Tyres: UN Regulation No. 141 (Tyre pressure monitoring systems)

Proposal for Supplement 1 to the 01 series of amendments to UN Regulation No. 141**Submitted by the Task Force on Tyre Pressure Monitoring System and Tyre Installation***

The text below has been prepared by the experts on communication interfaces of the Task Force on Tyre Pressure Monitoring System and Tyre Installation (TF TPMSTI) in order to update the requirements on the communication interfaces between towing and towed vehicles. The changes compared to the 01 series of amendments to UN Regulation No. 141 (ECE/TRANS/WP.29/GRBP/2020/20 as amended by GRBP-72-19-Rev.2) are marked in bold for added text and strike through for deleted text.

Figure 1

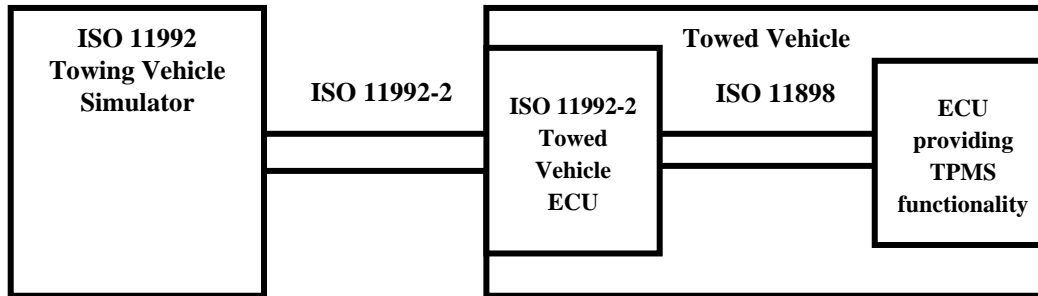
Arrangement of device under test and vehicle simulator where TPMS functionality is provided by ECU connected via ISO 11898-1:2015 and 11898-2:2016 interface

Figure 2

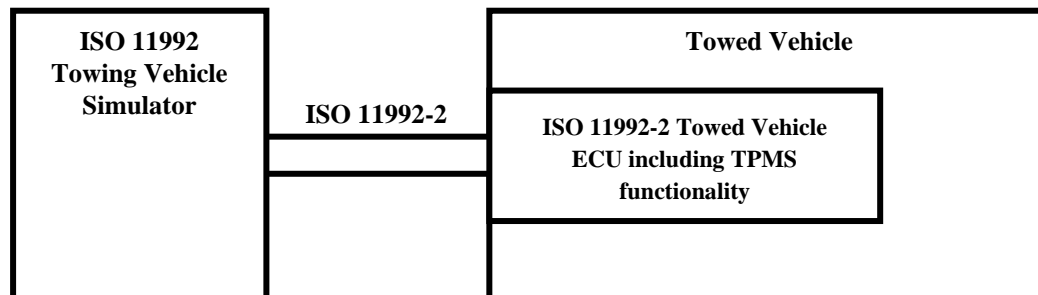
Arrangement of device under test and vehicle simulator where TPMS functionality is provided by ECU connected to towing vehicle
